Date: April 14, 2003

On July 19, 2002 this office issued a Notice of Noncompliance to you for failure to have an approved plan of operations and for failure to complete reclamation of unauthorized disturbance. Although you have expressed continued interest in pursuing approval of your plan of operations, we have not received any further documentation from you nor have you clarified the relationship between Interstate Rock Products and the reclamation bondholder, I & P Investments, as we requested in our letter of December 16, 2002.

1. Reclamation Map

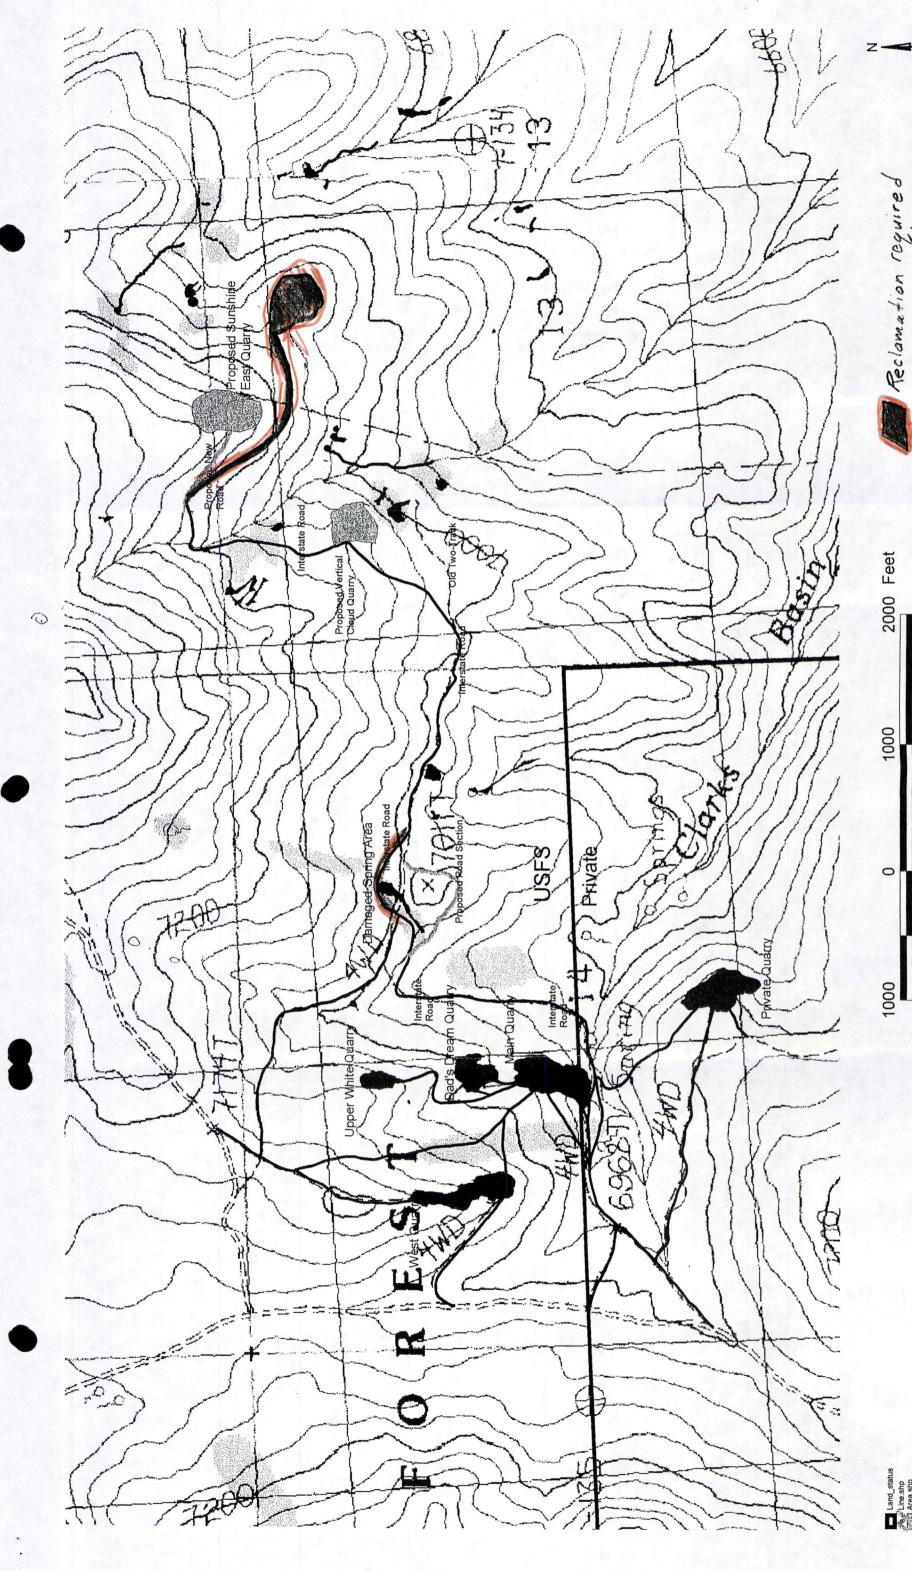
Because it has been over 2½ years since the disturbance was created, reclamation must begin as soon as possible regardless if you still wish to pursue approval for your plan of operations. Specifically, we request that the quarry area and a short section of access road to the quarry and the section of the road through the damaged spring area be reclaimed by May 15, 2003 (see attached map). Since Bonneville Quarries (Bown) is seeking approval to utilize the remainder of the road, reclamation of this part will not be required at this time. We are working with Bonneville Quarries to incorporate it into their plan of operations and to assume the reclamation responsibility for it.

- 1. Because of the damage to the archeological site at the spring area, a Forest Service or a Forest Service approved archeologist must be on site during reclamation to ensure that no further damage to the archeological site occurs.
- 2. The exposed spring needs to be armored with rock and recovered with soil from the existing disturbed area.

- 3. All restoration work should be accomplished with minimal disruption to the flow or disturbance to the substrate in the immediate vicinity of the spring since a lot of disturbance has already occurred just above the spring.

- 4. Care must be taken not to compact soils on and around the spring area during reclamation activities.
- 5. Steep sections of reclaimed road should be recontoured with waterbars if needed to prevent surface flow from following the road.

- 6. Because of the damage created within the spring area, this area will need to be fenced after re-contouring to allow it to recover quickly. This fence will also need a gate to allow access to original riparian crossing, which will be utilized until the Bonneville Quarries plan of operations is approved. We currently have an estimate for \$1865.00 for completion of fencing, but we have not completed the necessary biological and archeological studies that would need to be done before the fencing could be installed. Once these studies are complete, you will be required to either install the fencing under direct Forest Service supervision or provide the necessary funding to allow the Forest Service to install the fencing on its own.

- c. Agropyron trachycaulum Slender Wheatgrass
 - d. Lupinus argenteus Lupine
 - e. Penstemon humilis Penstemon
- 8. The reclaimed quarry area must be regarded to original contour. Topsoil, if available, must be spread over the recontoured quarry. The recontoured quarry must then be ripped along contour to prevent erosion and encourage establishment of vegetation.
